City of Portland, Maine – Building or Use Permit Application 389 Congress Street, 04101, Tel: (207) 874-8703, FAX: 874-8716

Location of Construction: **43 Bracket Ave. Peaks Island 04108		Owner: ** Paula Boulton		Phone: 766-2515		Permit No: 991114
Owner Address: SAA		Lessee/Buyer's Name:		Phone:		
Contractor Name: Robert Davis		Address:		Phone: 766-5531		Zone: IK-2 CBL: 087-LFL-017 Zoning Approval: 10/12/99 Special Zone or Reviews: <input type="checkbox"/> Shoreland N/A <input type="checkbox"/> Wetland <input type="checkbox"/> Flood Zone no CC-paid <input type="checkbox"/> Subdivision <input type="checkbox"/> Site Plan major <input type="checkbox"/> minor <input type="checkbox"/> minor <input type="checkbox"/> minor <input type="checkbox"/> minor
Past Use: 1-Family		Proposed Use: Same		COST OF WORK: \$ 5,000 PERMIT FEE: \$ 54.00		
Proposed Project Description: Screened porch & Deck. 14x14.7 - Deck 9x24		FIRE DEPT. <input type="checkbox"/> Approved <input type="checkbox"/> Denied Signature: _____		PEDESTRIAN ACTIVITIES DISTRICT (P.A.D.) Action: <input type="checkbox"/> Approved <input type="checkbox"/> Approved with Conditions <input type="checkbox"/> Denied Signature: _____ Date:

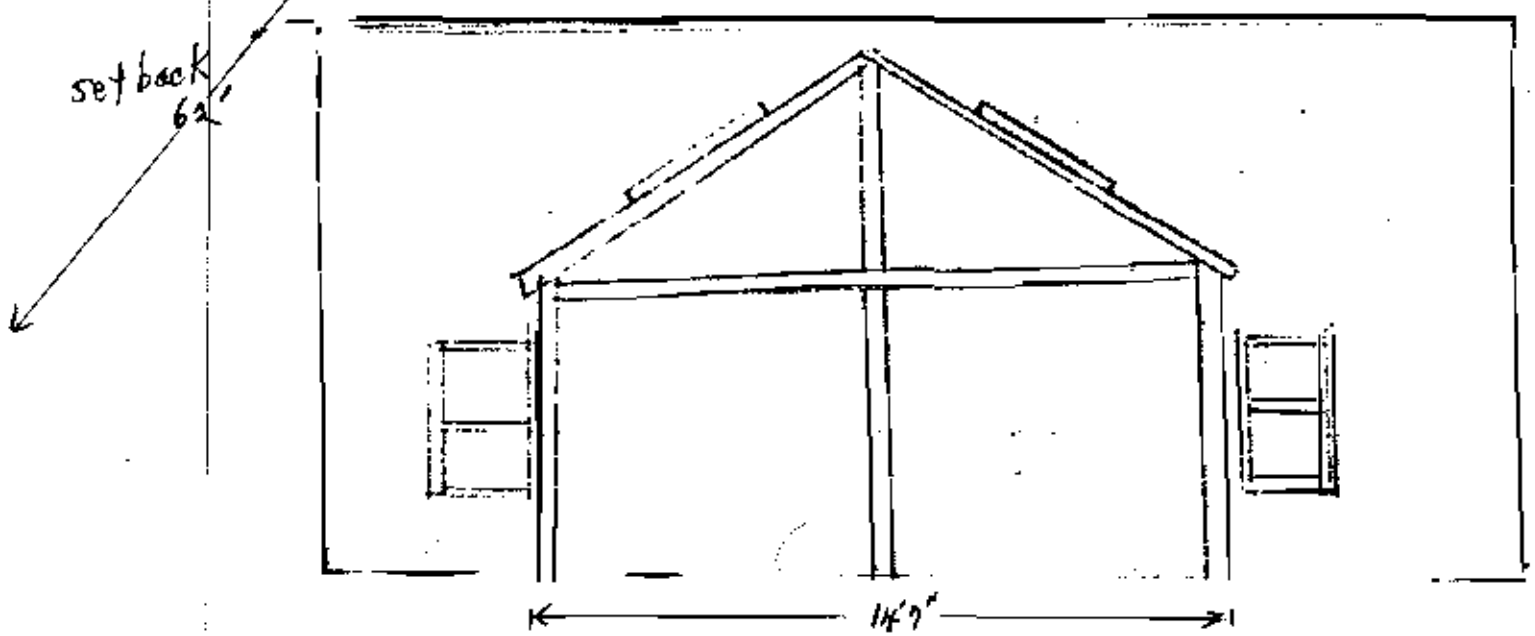
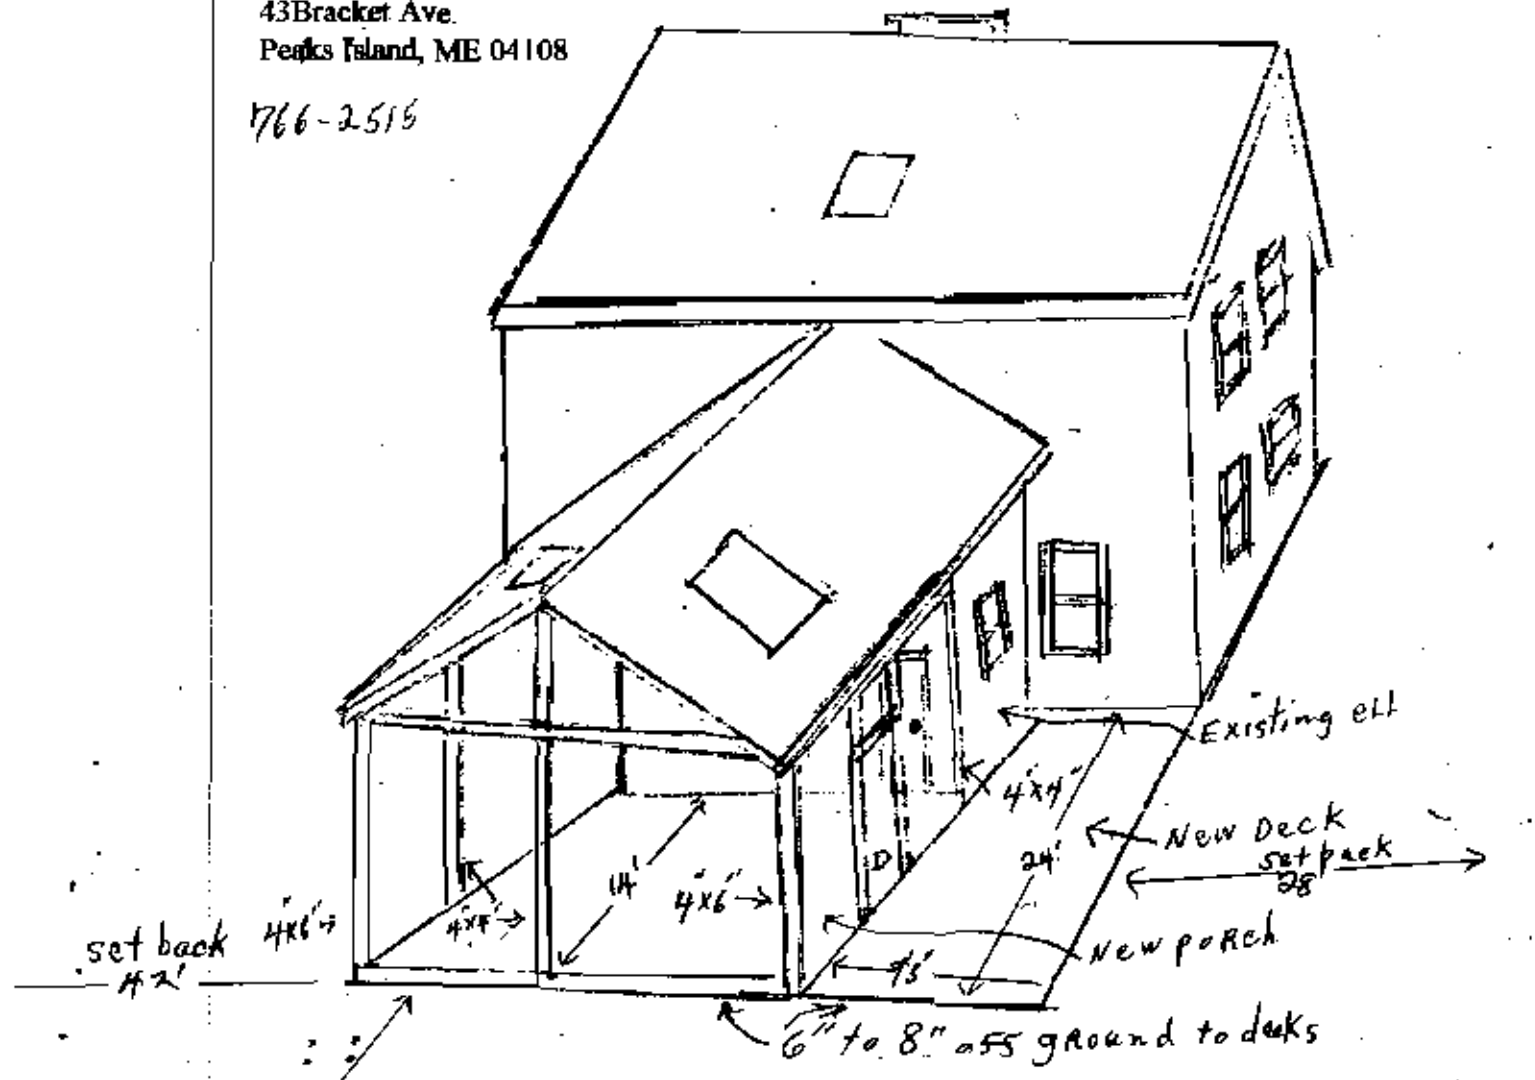
Pier (Sono Tube) spacing
MAXIMUM of 8'

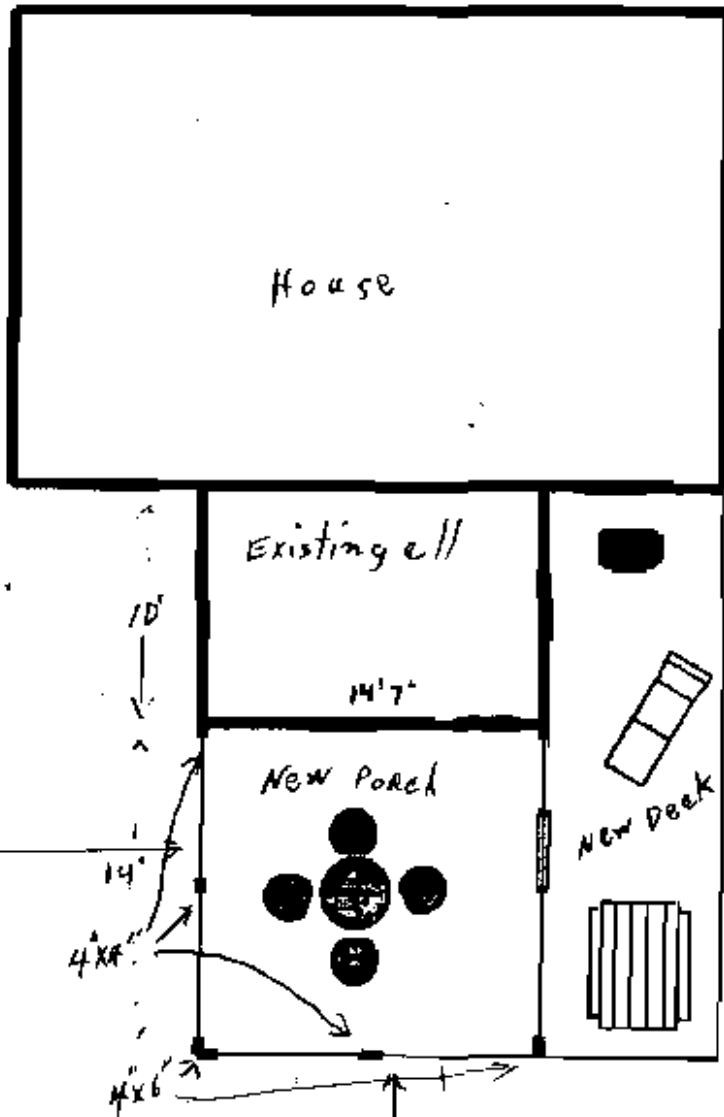
Needs to be from lot property lines

A) front 25' to the lot line
20' show (not necessarily the Rd)

B) Rear 25' req - 42' show

C) Side 1d - 20' req - 62' show
